2023 Sewer Main Replacement Project 3
Solicitation Number: CO-00724
Job No.: 23-4519

ADDENDUM 2
April 22, 2024

2023 SEWER MAIN REPLACEMENT PROJECT 3
SITE A - COMPKY 969666 & 968957
STA. 4+00 TO STA. 5+82.56
SANITARY SEWER REHABILITATION

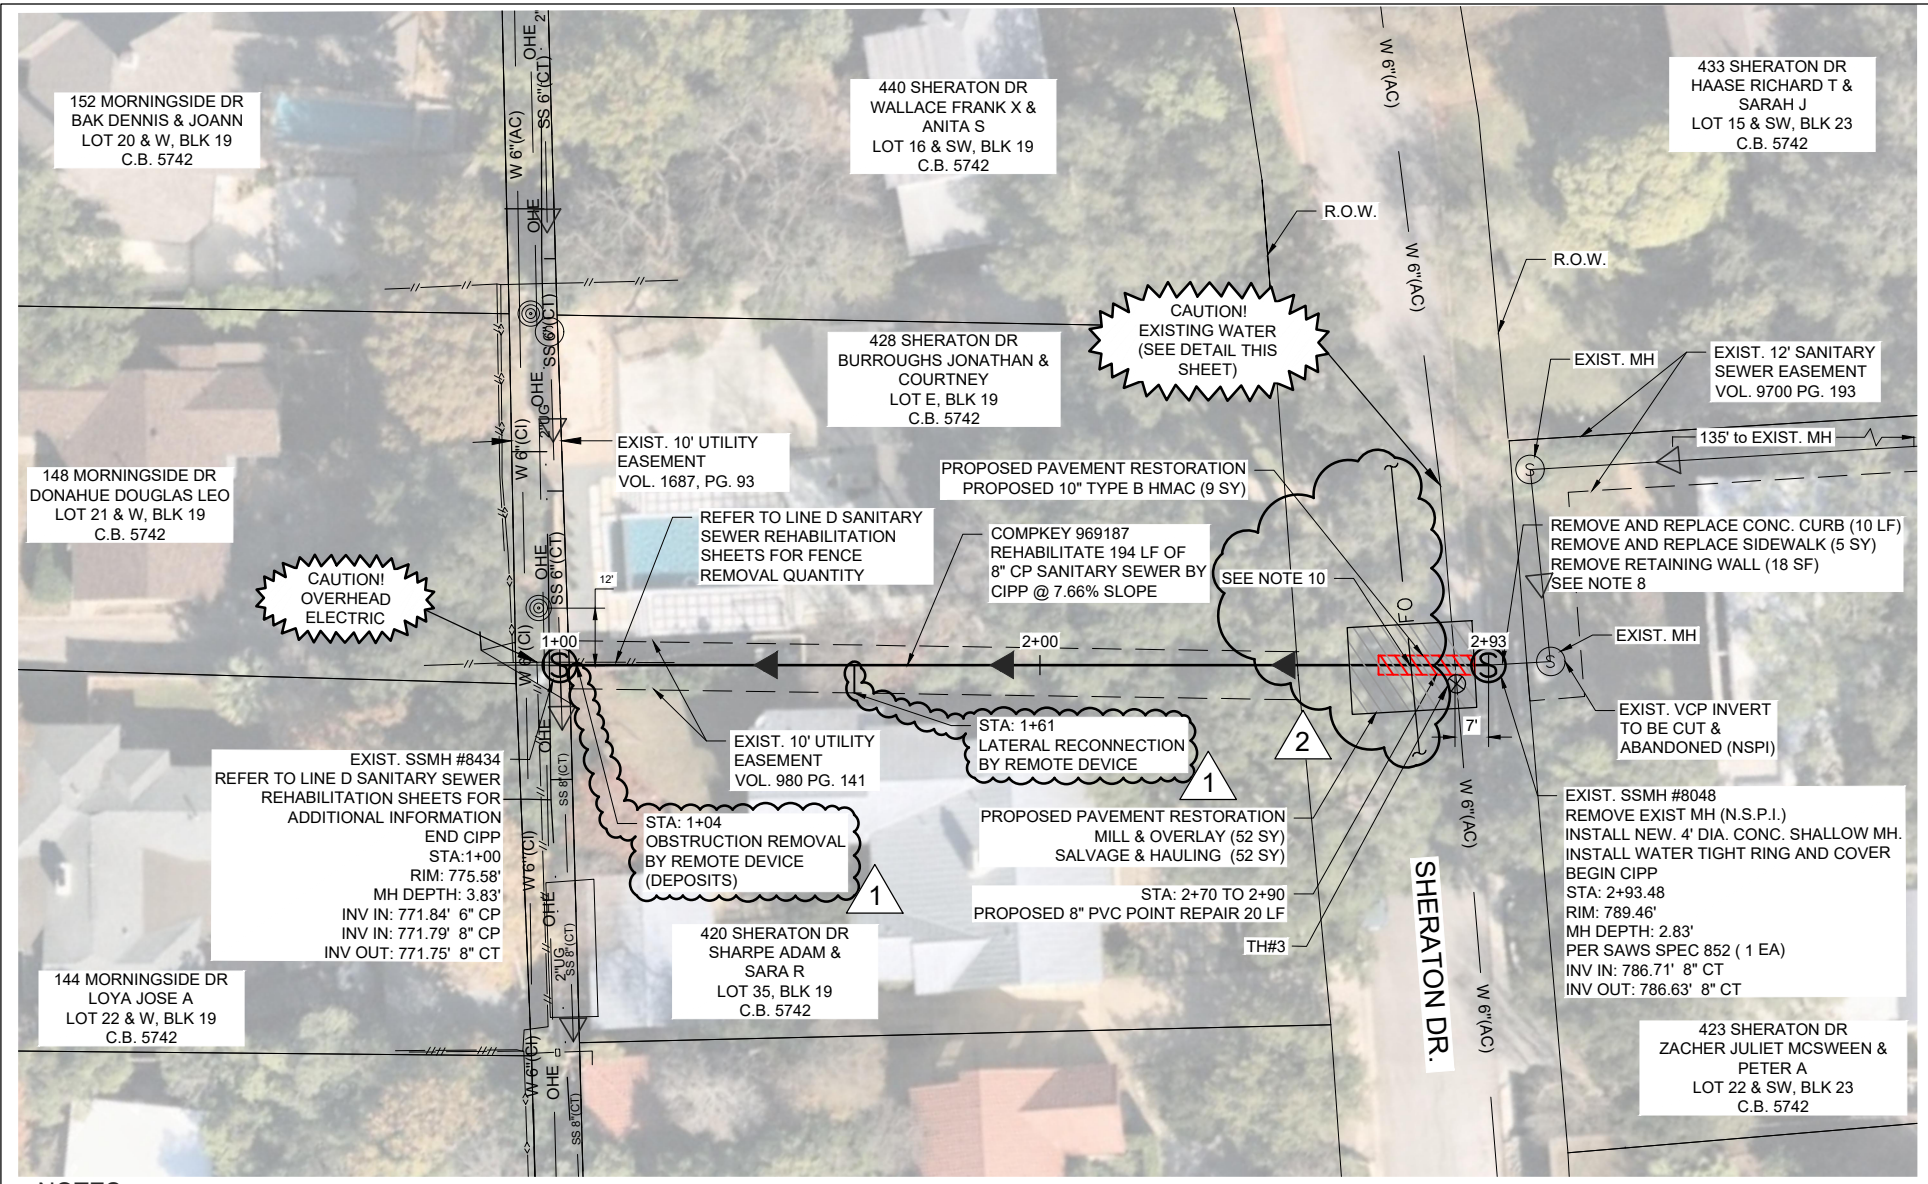
- 1. Remove the following and replace with the attached sheets.
 - Site A – Compkey 969666 & 968957, Sta. 4+00 to Sta 5+82.56 Sanitary Sewer Rehabilitation – Sheet 7
 - Added an AT&T underground telecommunication utility to the plan view and added a note for the contractor to verify location prior to construction.
 - Site E – Compkey 969187, Sta. 1+00 to Sta. 2+93.48, Sanitary Sewer Rehabilitation – Sheet 18
 - Added an AT&T underground telecommunication utility to the plan view and added a note for the contractor to verify location prior to construction.

- APPROXIMATE LOCATION OF AT&T DIRECT BURIED (NO CONDUIT) FIBER OPTIC LINE. CONTRACTOR TO LOCATE AND VERIFY ALL UTILITIES PRIOR TO COMMENCING CONSTRUCTION (N.S.P.I.).
